Product/Group No. CAM-SHAFT FOR 692 ϕ D.I. ENGINE WITH 94 AIR COMP.

Drg./Part Designation: FORM-CUTTER

Drg./Part No. 8800.470.349.00

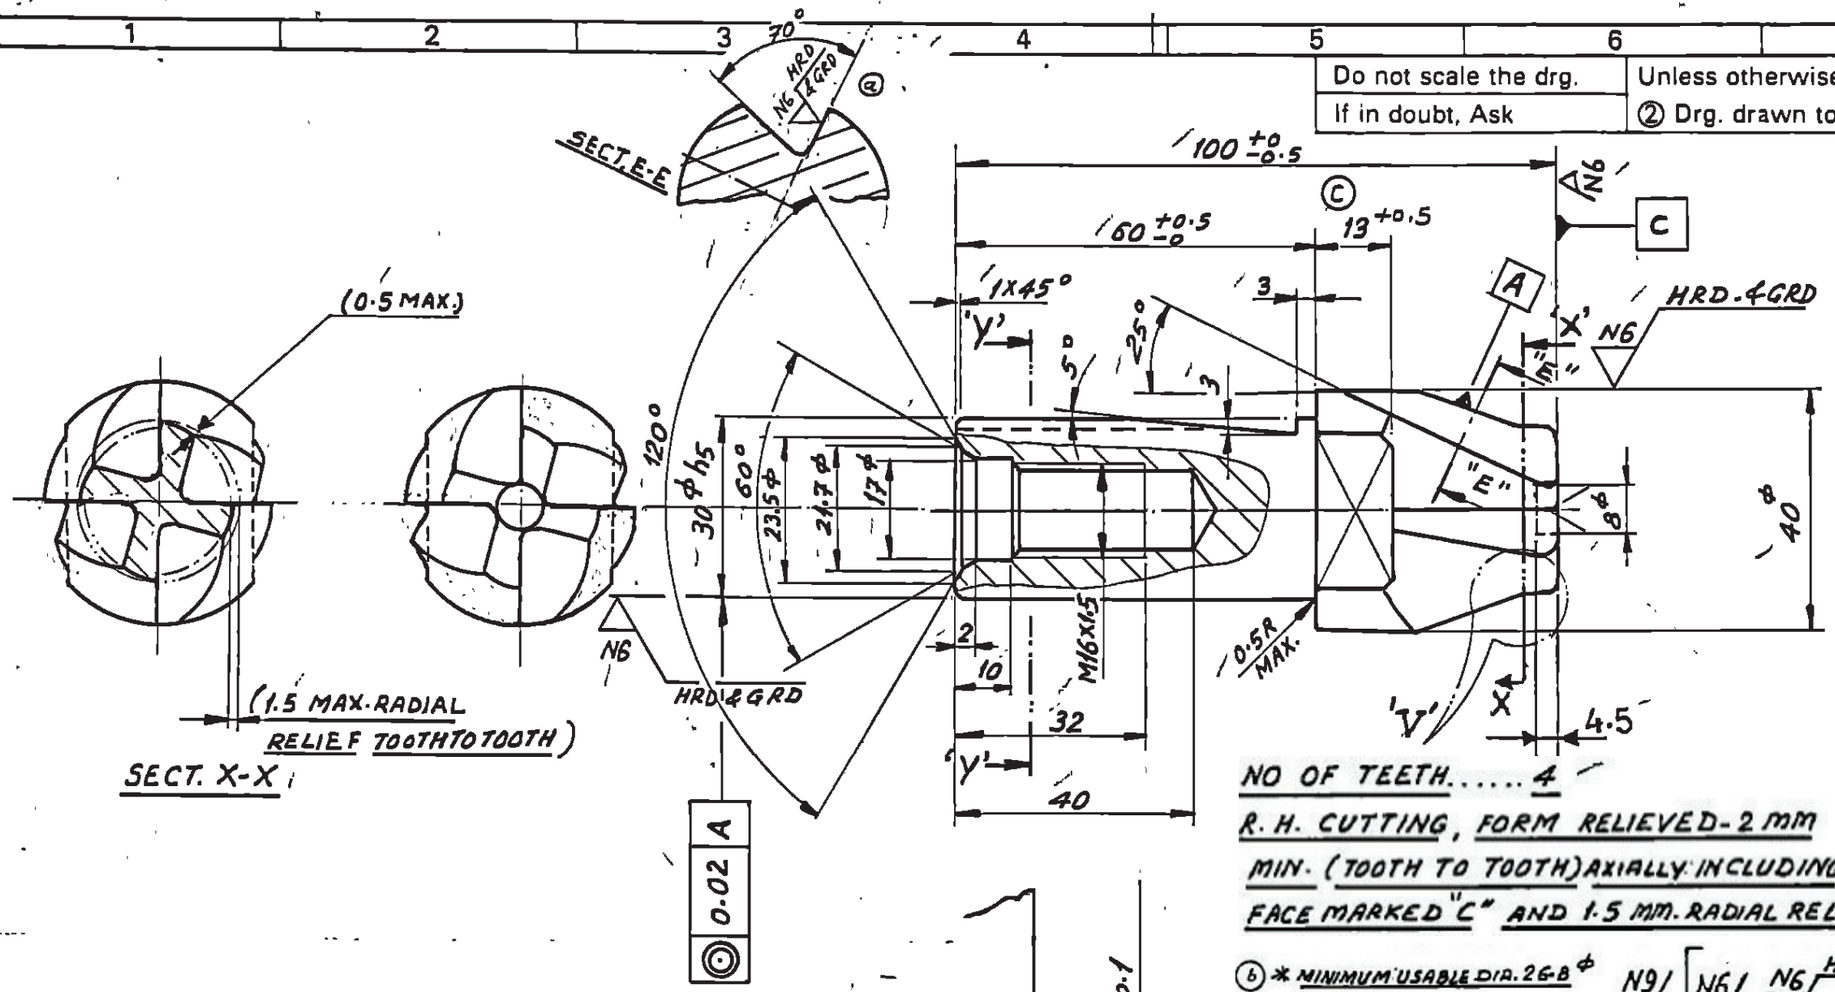
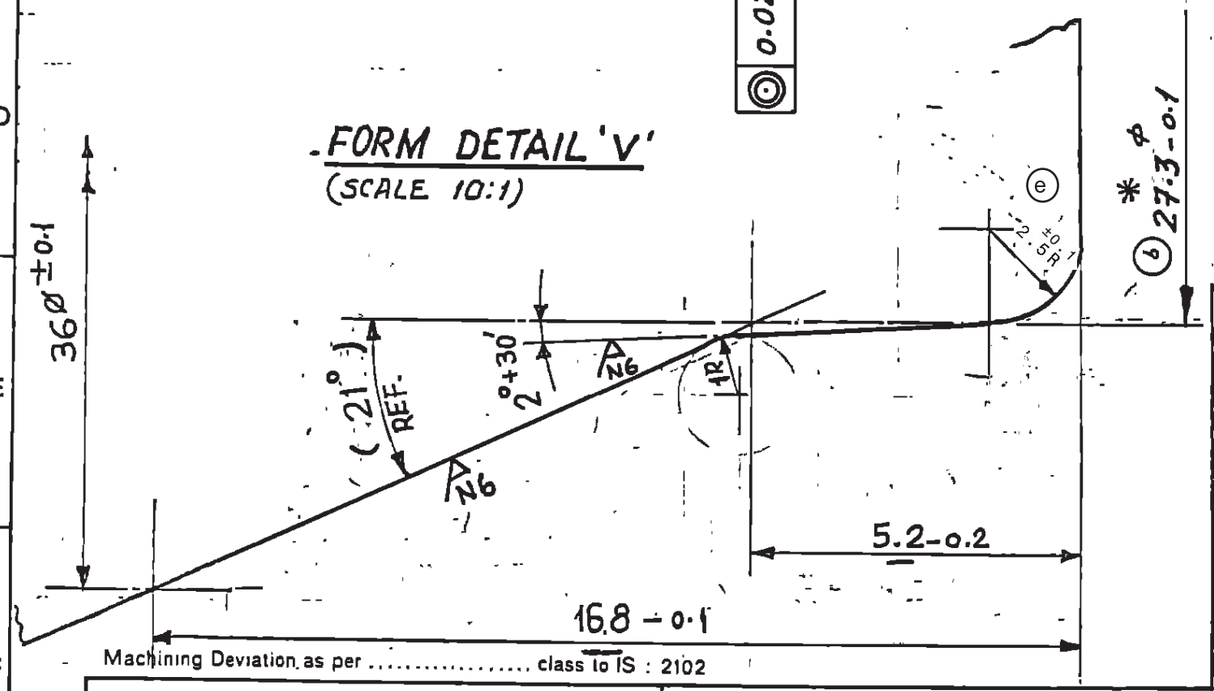
03/04 2018	ⓔ			RADIUS 2.5R ±0.1 WAS 1.5R ±0.1 MODIFIED AS PER SHOP FEEDBACK	ABP	RSS
27.11.04	ⓓ			MISSING HARDNESS VALUE HRc 63 TO 65 ADDED		
11.4.03	ⓒ			DIMN. 13 +0.5 WAS 13 MOD. AS PER TIC REPORT		
19.7.92	ⓑ		E-4	DIMN. 27.3-0.1 WAS 27-0.1 modified as per EMA Inductor size Ref. APL Letter	AVM	
17.12.90	ⓐ			RACK & 8° DELETED (modified as per 8800.470.850.00) mod ⓐ		
Date	Mod No	S.No	Zone	Modification	D.O.	STDZ
